MEMORANDUM

SUBJECT: Planning Case 22-020 – Concept Plan Review
Variance – 1861 Highway 96 W.

Proposed Redevelopment Building Site

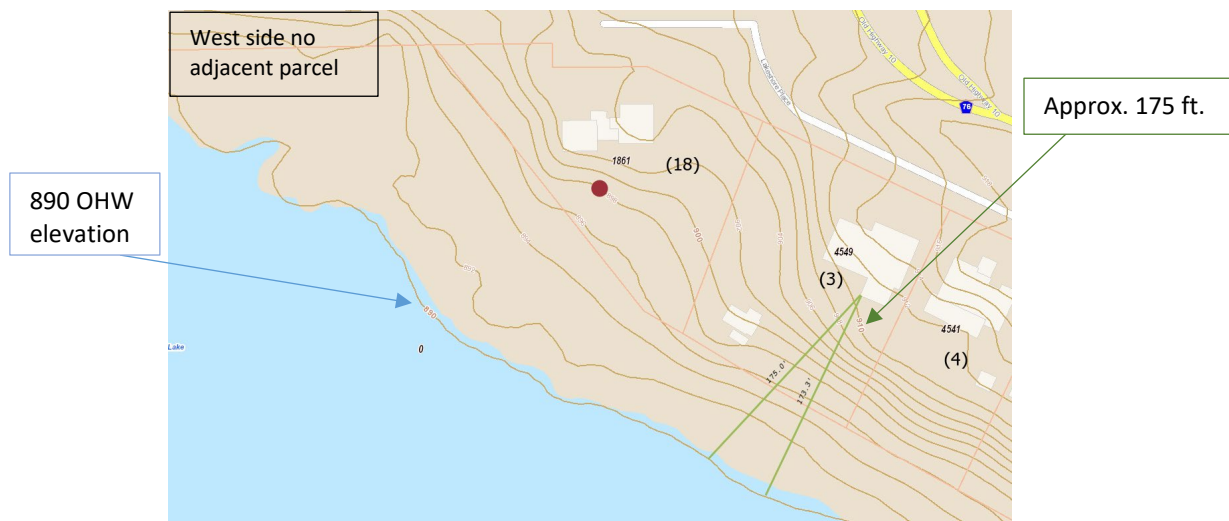
R-1 District Standards	Shoreland Overlay District	Existing	Proposed
Minimum Front Yard Setback	40 feet	40 feet	29.57 feet (North)	28.11 feet (North)*
Minimum Rear Yard Setback	30 feet	75 feet from OHW & Setback of Adjacent Lots	-30.34 feet (West) as measured from Property Line -92.9 feet as measured from OHW	- 36.10 feet as measured from Property Line (West & SW) - Approx. 100 feet as measured from OHW**
Minimum Side Yard Setback	10 feet (min)/25 feet (total)	N/A	71.81 feet (East)	34.9 feet (East)

*Variance requested by Applicants

I will note that it has been requested of the Applicants that they verify with their surveyor as to the delineation of the Ordinary High Water (OHW) elevation on the Certificate of Survey. The distances as stated above are based upon the distances identified on the survey as measured from “Shoreline”.

One additional item in further review of the concept plan, city staff identified using Ramsey County GIS map that the adjacent lot to the east may have a greater setback of approximately 175 feet from OHW. The City’s shoreland regulations does require new development and additions on a riparian lot to have a setback from OHW as measured in relation to adjacent lots.

Planning staff verified that the City does not have a Certificate of Survey on file for the adjacent property at 4549 Lakeshore Place. The Applicants would be required to provide evidence of the setback from OHW for the adjacent lot in order to verify compliance with Section 1330.03, Subd. 4 as part of their future land use application or apply for a second variance from this provision if their new dwelling would be less than the minimum requirement.
